Docket Nos.: 50-352  
50-353

Subject: Limerick Generating Station, Units 1 and 2  
Request for Additional Information  
Limerick SPDS Review

The reference letter requested additional information on Limerick's Safety Parameter Display System (SPDS). This information is provided in the attached draft FSAR pages that will be incorporated into the FSAR via Revision 35 which will be submitted in August, 1984.

FIGURE ④: RPV CONTROL DISPLAY

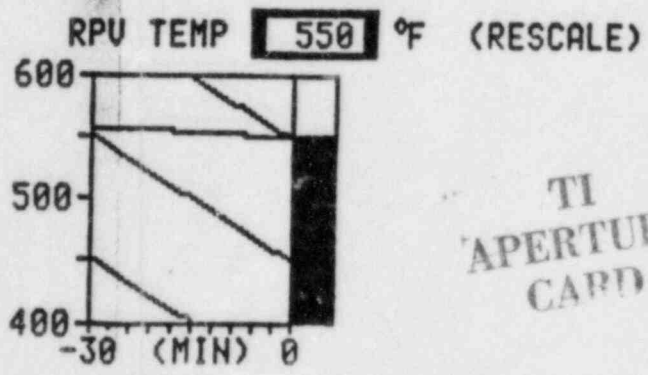
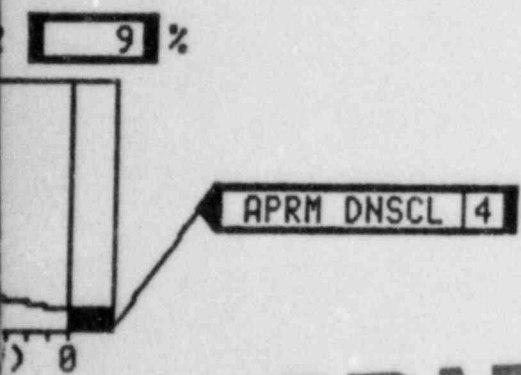
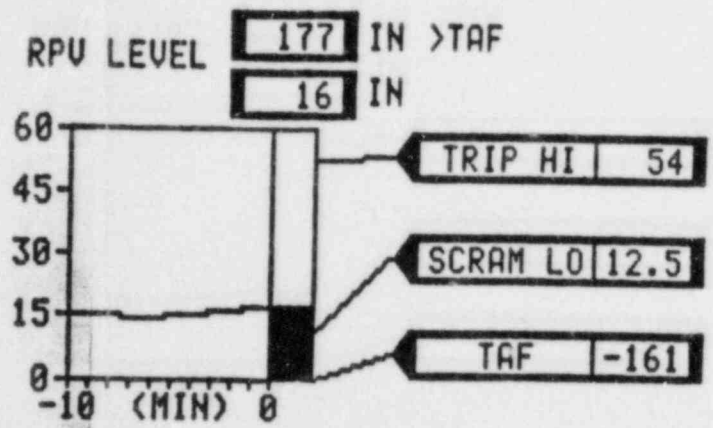
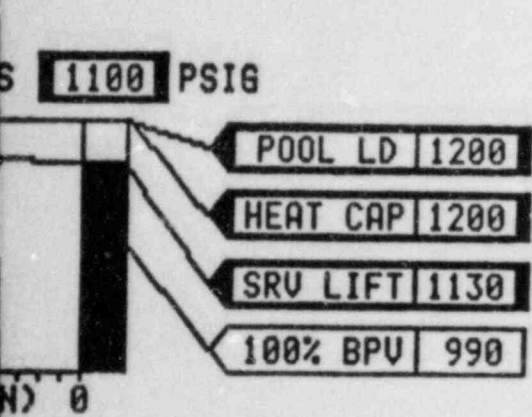
Reactor Pressure Vessel (RPV) pressure is an entry condition for the BWR Emergency Procedure Guidelines. This parameter should be included in your SPDS under Reactor Pressure Vessel Control. If this process variable is not included in the final SPDS design, provide a justification for not including it.

This display provides control room operators with the primary plant information required to execute the LGS EOPs developed from the RPV Control Guideline. This display is not intended to provide information to unlicensed personnel or personnel whose emergency response functions are not defined by the EOPs (e.g., engineers, supervisors, or management), although these personnel may certainly utilize this display for detailed plant status information. The RPV Control Display is shown in Figure 620.02-1.

RPV pressure is included in the  
RPV control display (Figure 620.02-1).

FIGURE 7. CONTAINMENT CONTROL DISPLAY

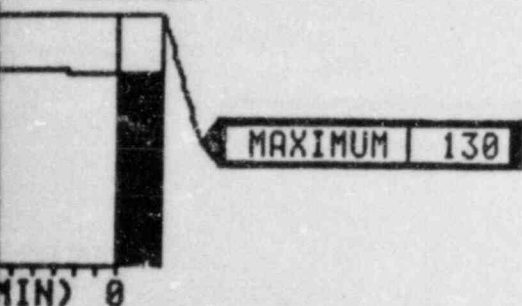
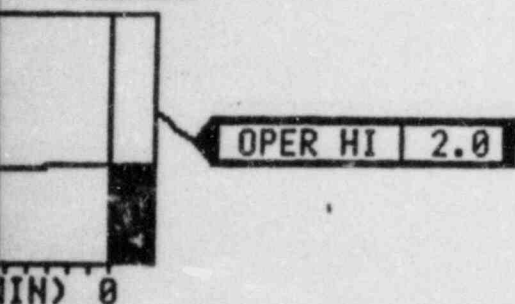
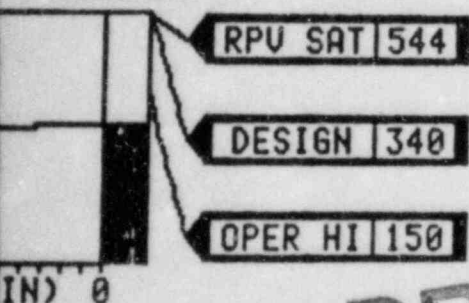
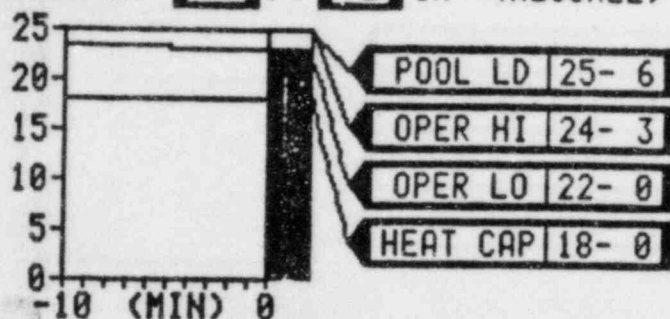
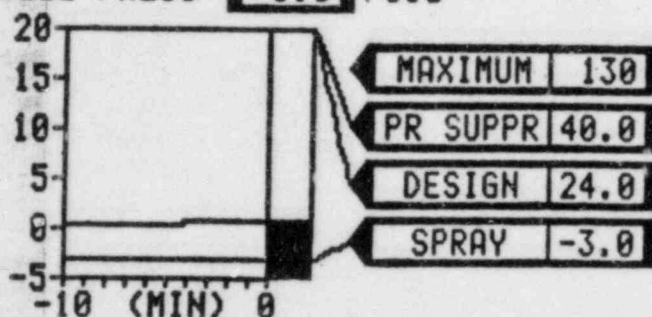
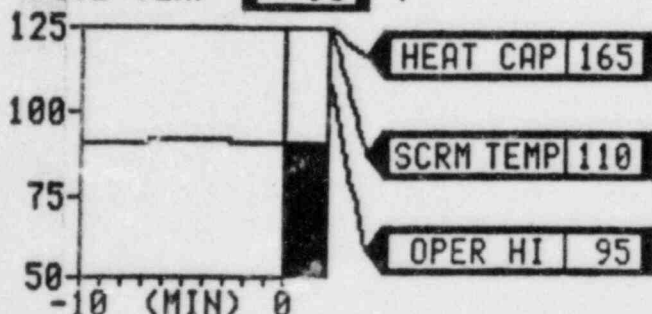
Provide a description of the display, its human factored design, and the methods used and results from a human factors program to ensure that the displayed information can be readily perceived and comprehended so as not to mislead the operator.

This top-level display provides control room operators with the primary plant information required to execute the LGS EOP developed from the Containment Control Guideline. The Containment Control display is shown in Figure 620.02-2.
